MOLA
Architecture

Tandy's Lane Phase 2

Planning Ref no. SDZ 22A / 0006

In response to Planning Conditions 13 and 21

Site Plan at Planning Compliance stage - 2no. B5.1 unit have been omitted and 1no. A5.1 unit is now included

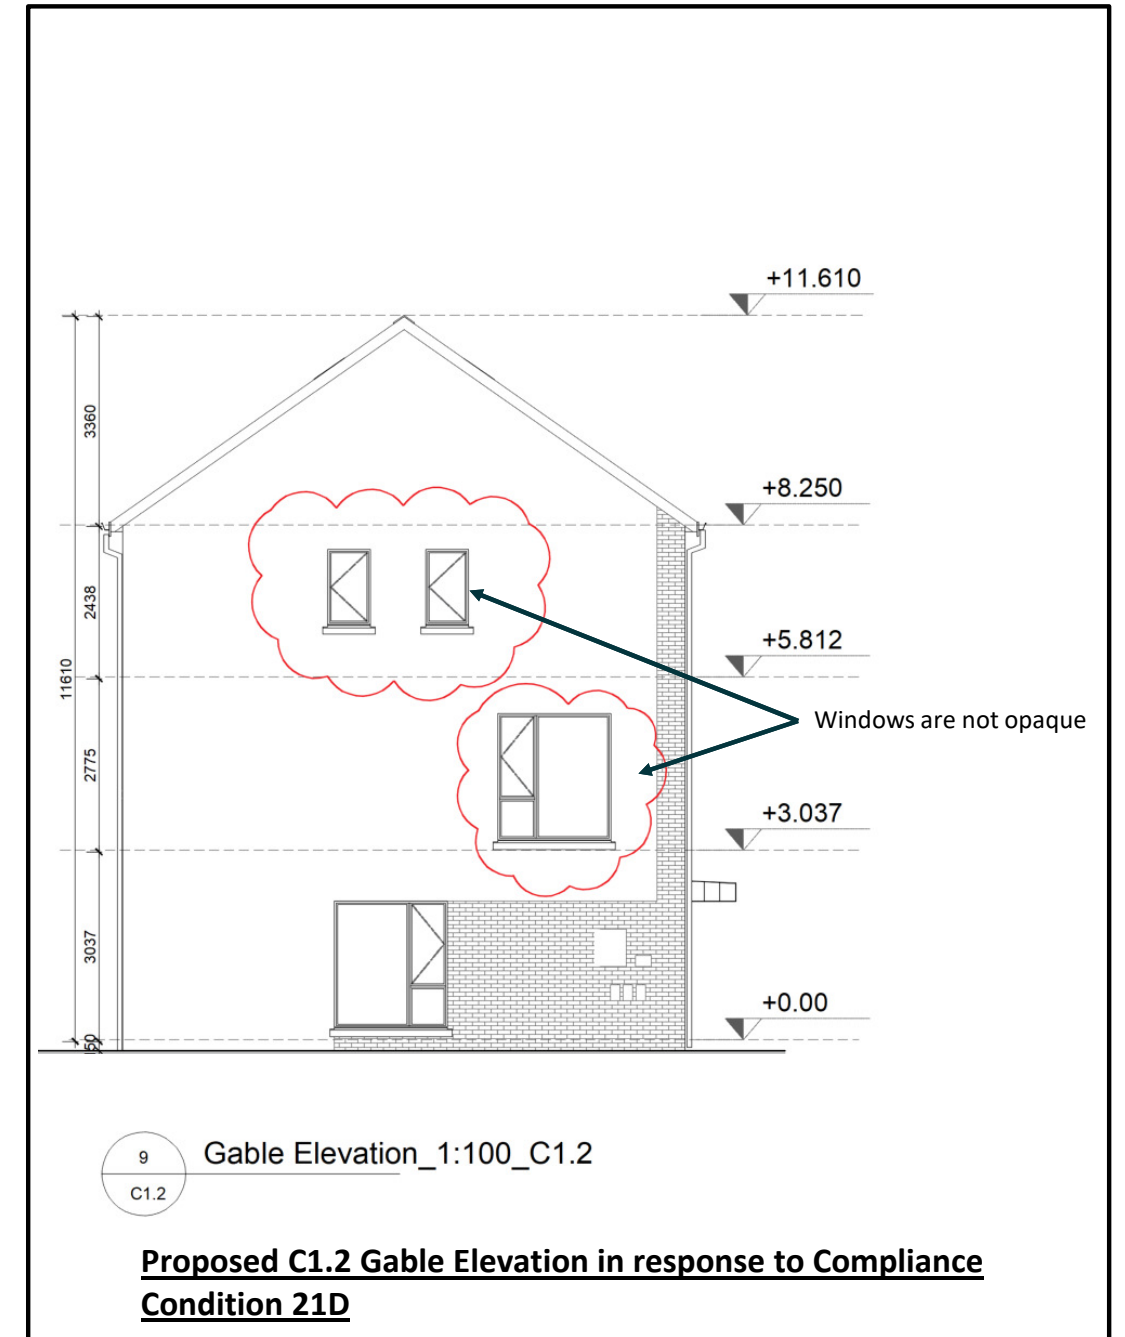
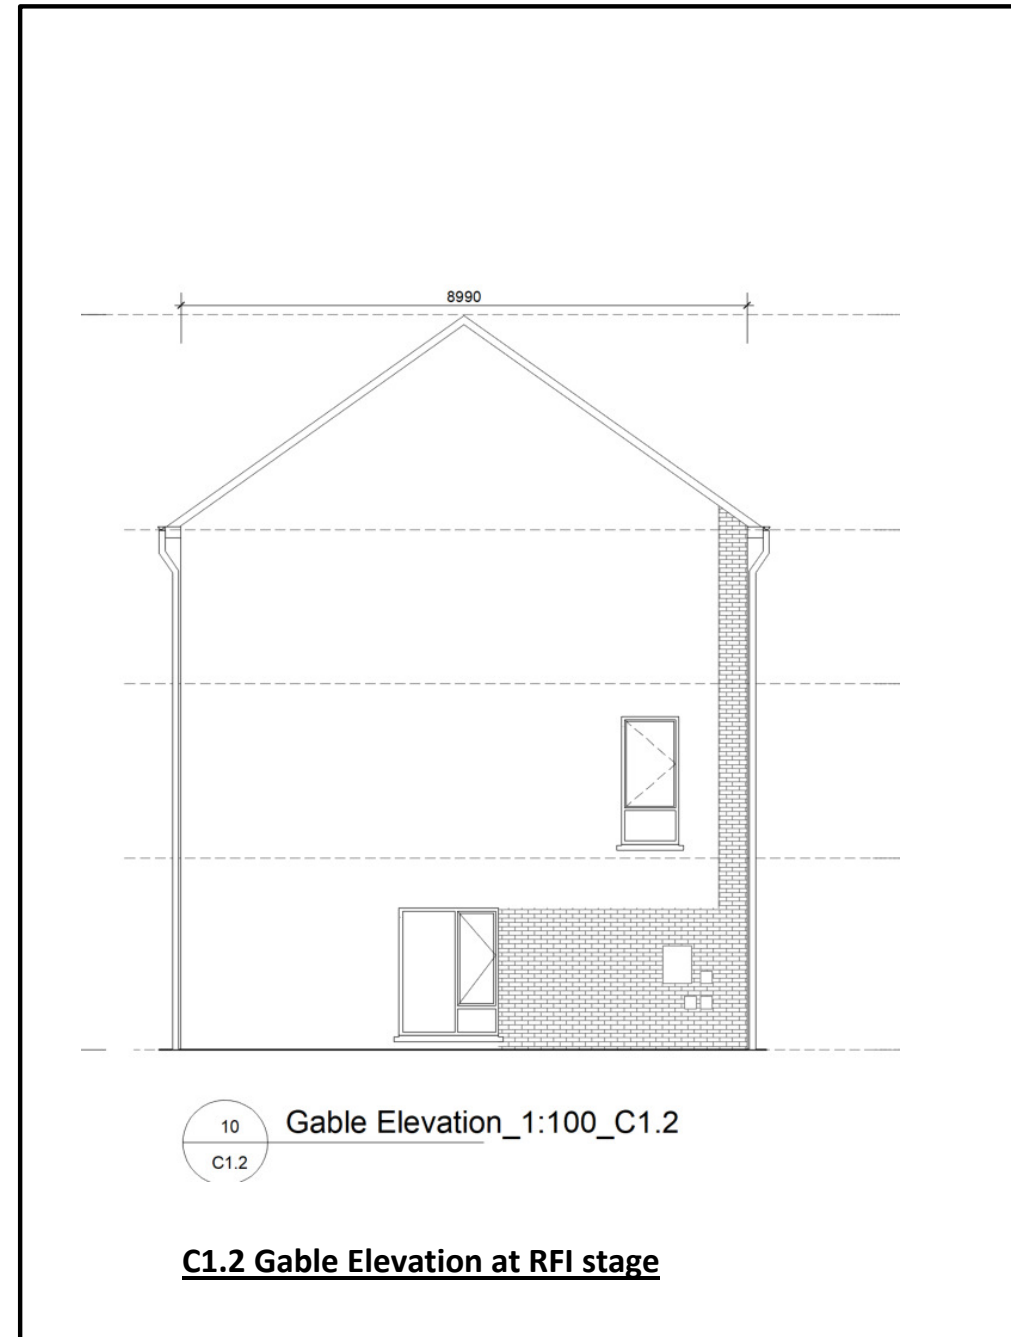
(c) The southern east-west pedestrian connection revised to include cyclist access to Adamstown Boulevard from the site.

Response to 21 (c): The southern east-west pedestrian connection is revised to include cyclist access to Adamstown Boulevard from the site. This block has been reduced by one unit in total - 2no. 3 bed units (Unit type B5.1) which are 2 storey were omitted and 1no. 4 bed unit (Unit Type A5.1) which is 3 storey included to achieve the gap needed for a pedestrian/ cyclist link. Please refer to drawings 0100 and 0100A. Please also refer to revised Schedule of Accommodation for the revised unit numbers.

MOLA CONDITION 21 D

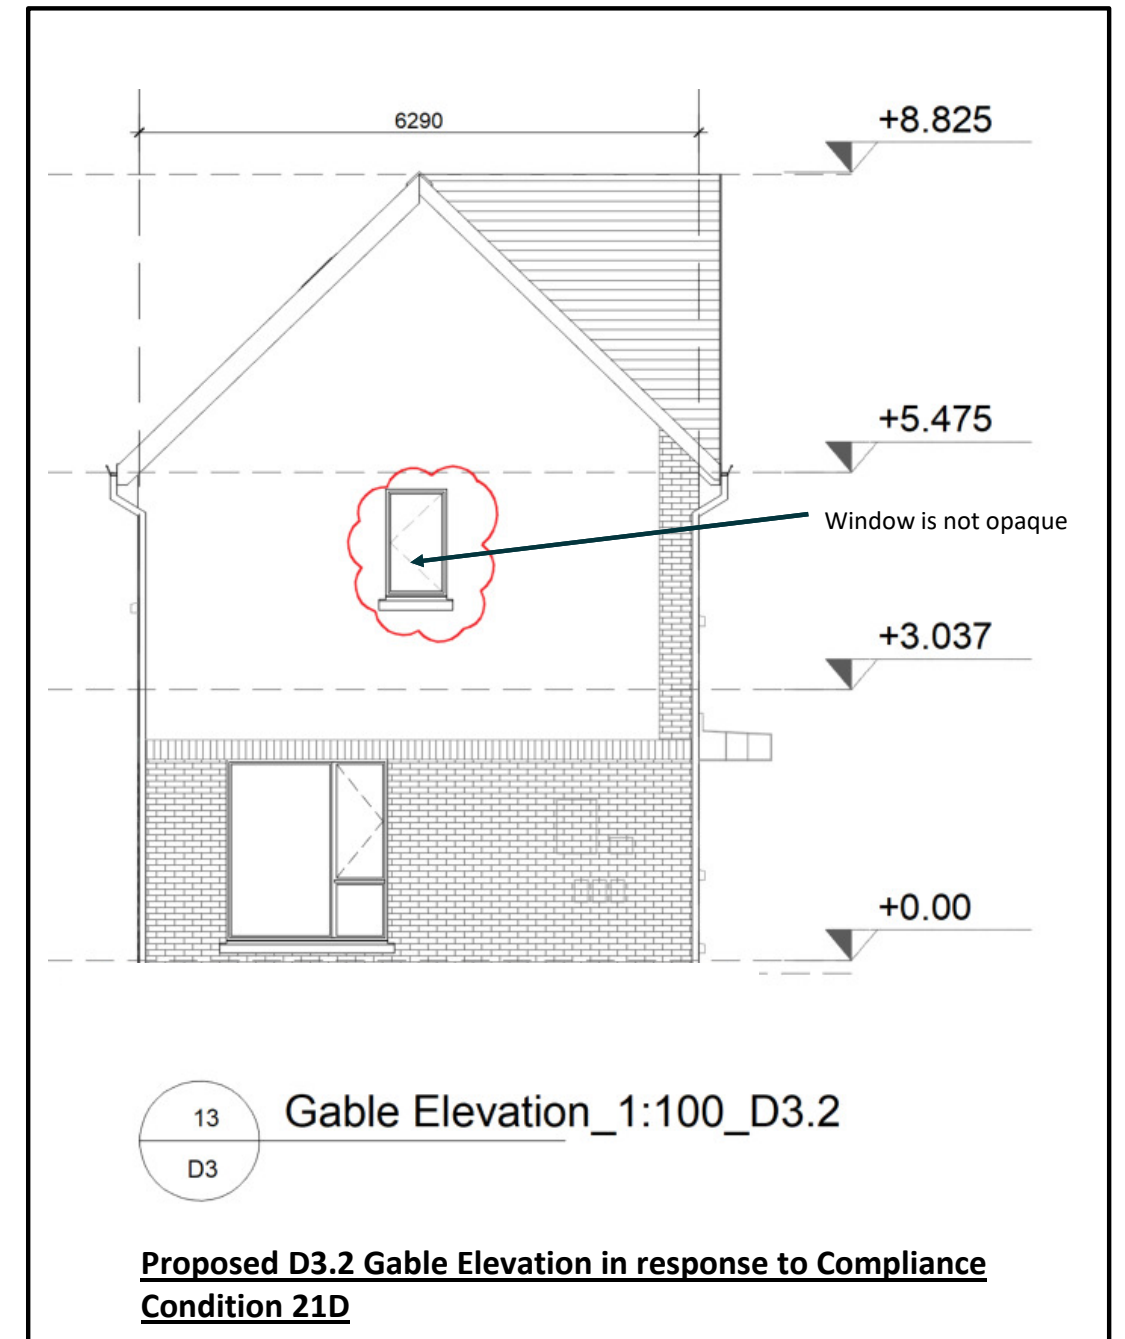
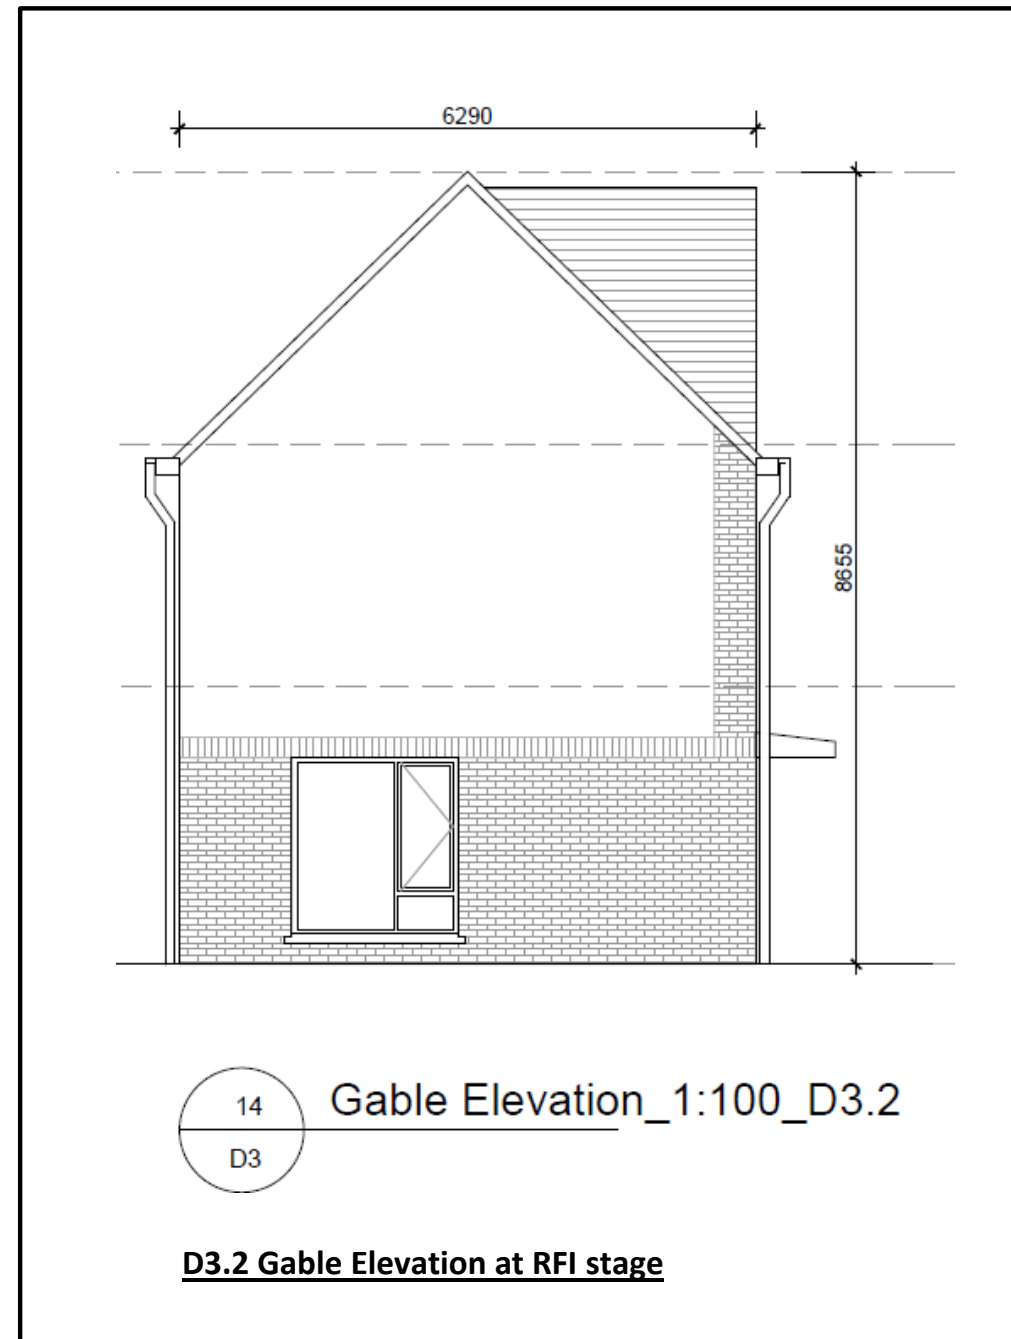
(d) House types C1.2 and D3.2 revised to include further window fenestration on the upper floors. Opaque glazing may be used to non-habitable rooms where appropriate.

Response to 21 (d): House types C1.2 and D3.2 are revised to include further window fenestration on the upper floors. The proposed additional windows are to bedrooms and are not required to be opaque Please refer to drawings 0415 and 0419.

REVISION IN RESPONSE TO CONDITION 21 (E)

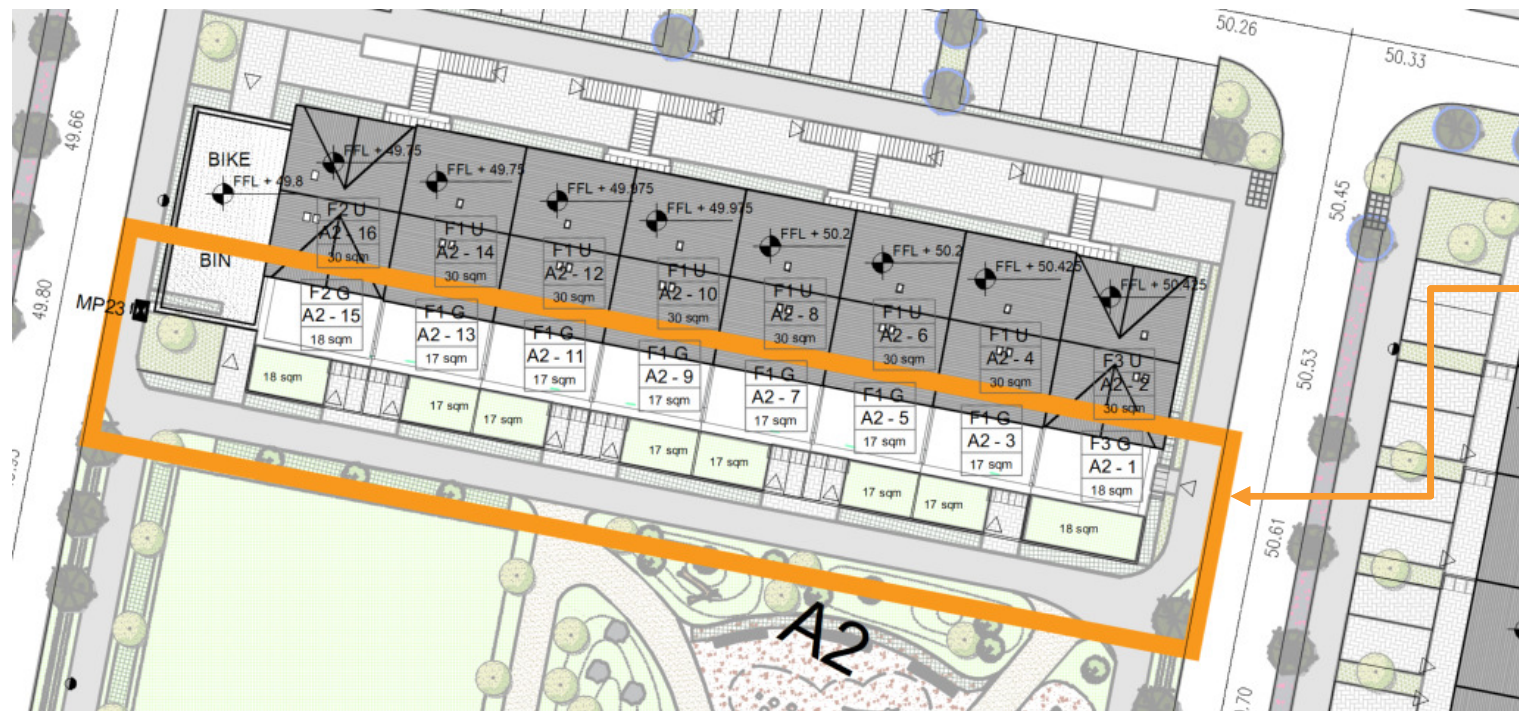
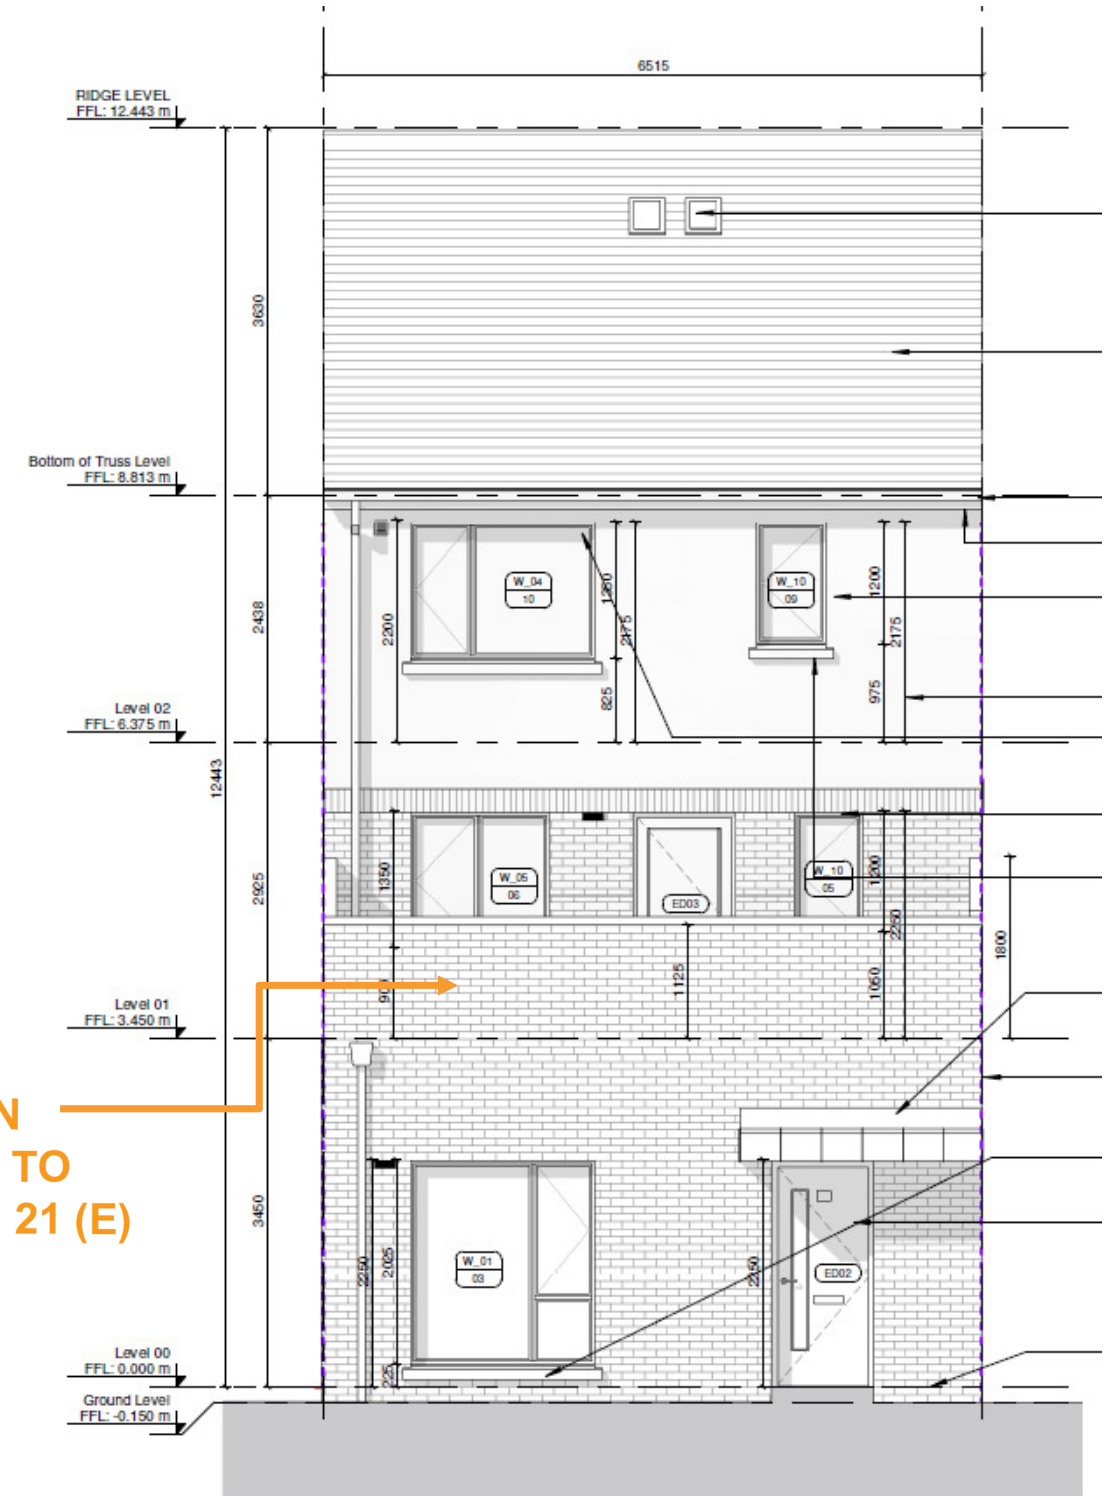
(e) The private amenity spaces of the ground floor duplex units in Block A2 shall be enlarged, to adequately compensate for no provision of semi-private amenity space, and a privacy strip provided outside the boundary of these with the public footpath. The proposed railings along the rear boundary of all the upper floor duplex unit roof terraces shall be revised to provide a more appropriate boundary that avoids overlooking into the private amenity space directly below, and allows for passive surveillance of the park (in the case of the units facing the northern pocket park).

Response to 21 (e): The private amenity spaces of the ground floor duplex units in Block A2 which were previously 14 sqm minimum are increased to 17 sqm (14 sqm if the footpath to the front door is excluded) the combined requirement for private and communal amenity space for the ground floor 2 bed units is 14 sqm (7sqm + 7 sqm as per the apartment guidelines).

A privacy strip is provided outside the boundary of these with the public footpath.

The rear boundary to the upper floor duplex unit roof terrace is revised as a solid wall to avoid over looking into the private amenity space directly below while still allowing passive surveillance of the park.
